1 Products affected

Product hierarchy no. *			Part no.	SBU	Type / Description	Customer part no.
SBU	PG	PGU Type				
02	007	043	0000002290	4790.1100	Connectors	4790 Connector for cable 16A
				4790.1200	Connectors	4790 Connector for cable 16A
				4790.1200.01	Connectors	4790 Connector for cable 16A

2 Type of change

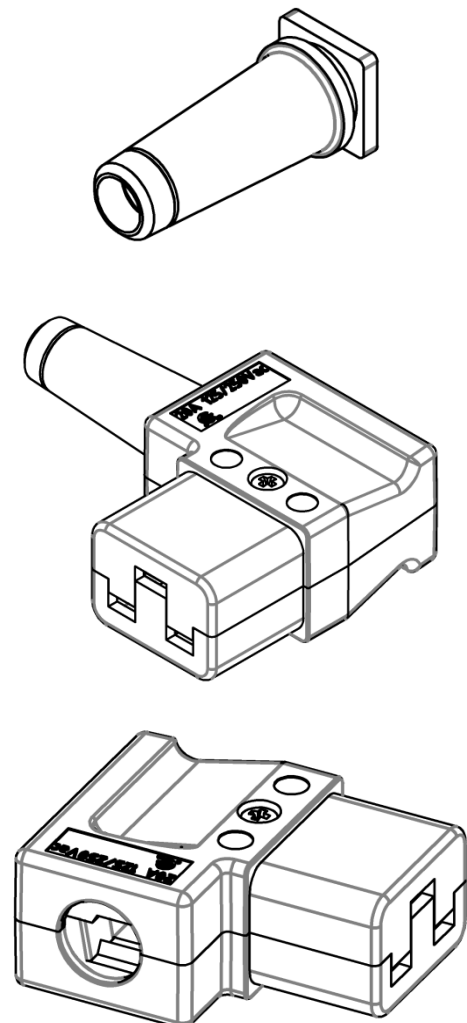
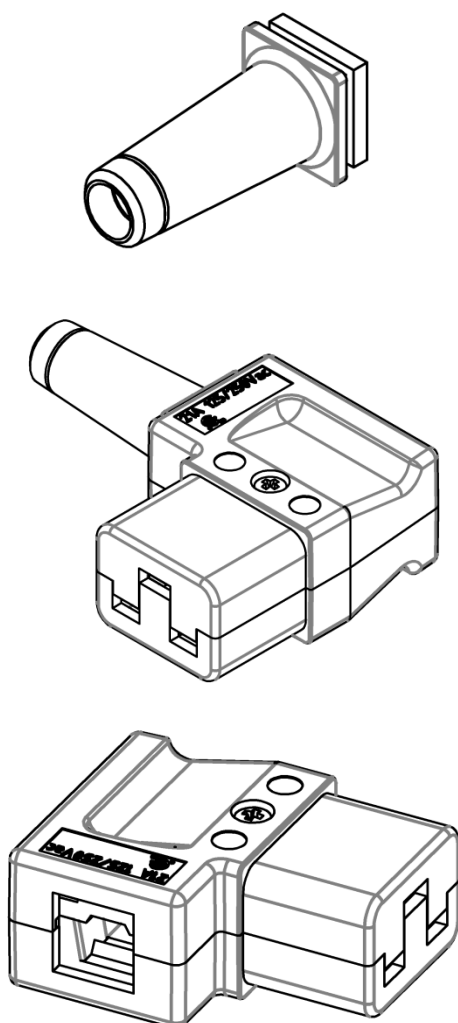
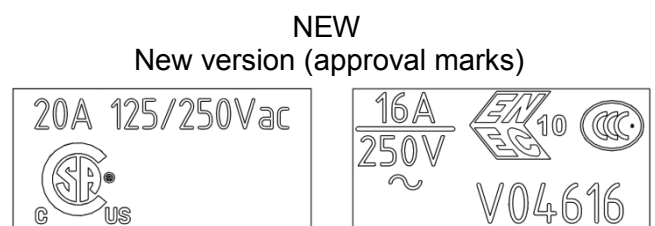
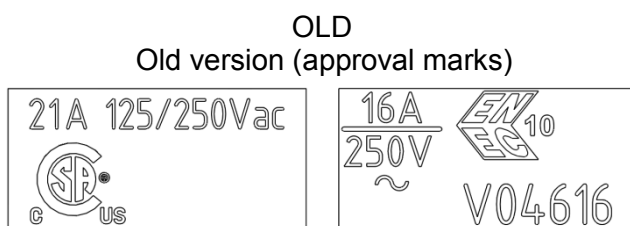
Renewal of the approval marks.

The opening for the cable guard is new round for improved fixture in the housing.

The marking UL/CSA rating 21A has changed according to UL60320 to 20A.

To pass the stronger test requirements according to IEC 60320-1 (Sect. 22: Cords and their connection), flange and slot on the cable guard had to be reinforced. As there have been made new tools for the moulding parts the holding of the cable guard got improved with a round opening.

Form: Round opening for the cable guard / New approval marks
Fit: n/a
Function: n/a
Production Site: n/a
Product Label: n/a
